To: Brookline Board of Appeals

Subject: Convert existing three-family dwelling into a four-family dwelling through renovation of the basement

Location: 10 Fuller Street

RE: Changes to proposed design per Planning Board meeting 02.08.18

PROPOSED
FLOOR PLANS

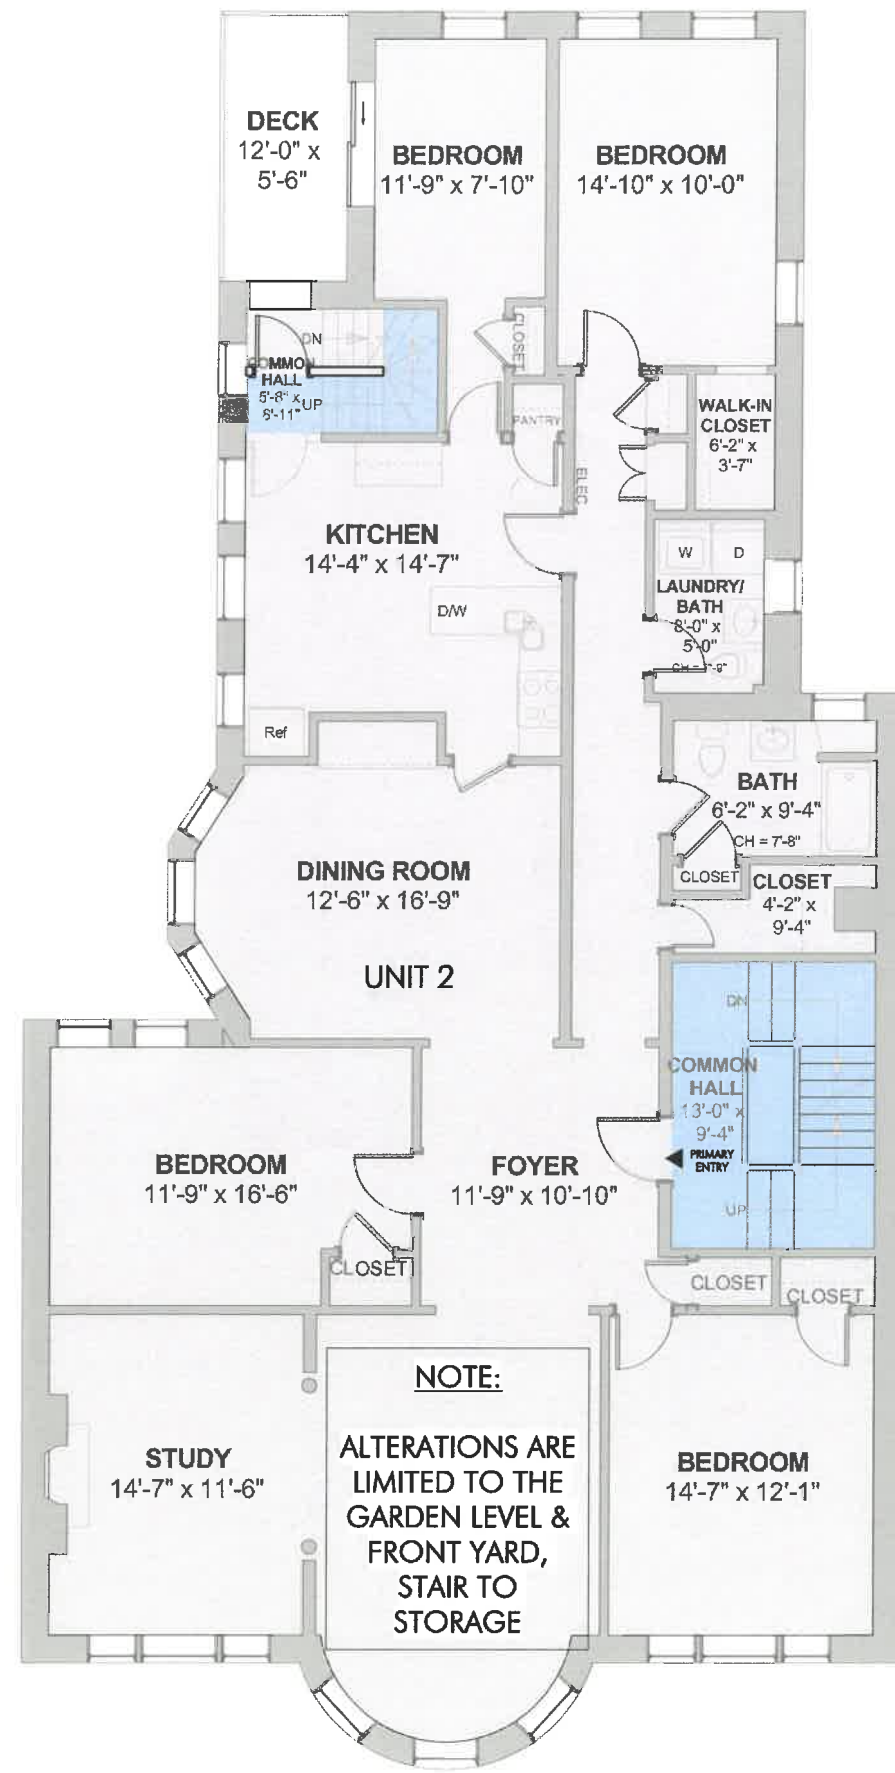
February 8, 2018: The Planning Board heard this case and raised concerns about the large increase in FAR necessitating a variance. The Board discussed options for the applicant to offer a benefit to the Town such as an affordable unit. They also requested that additional trash space and storage be added, the roof deck be shrunk and trash barrels be removed from the front yard.

- Garden level unit reduced from a 2,352 SF unit to 1,342 SF (plus 148 SF for egress, total 1,490 SF which is an 862 SF reduction.
- Added 830 SF of Common Building Area for dedicated Trash and Recycling, and Bike and Storage room with two means of egress for access either to front or rear stair to Winchester Street via common passage way.
- Reduced roof deck from 700 SF down to 280 SF (420 SF reduction), by pulling back front railing by 20' (from 35' deep to 15' deep).
- Added 450 SF of landscape roof garden.
- Called out for landscape front yard and no trash receptacles.
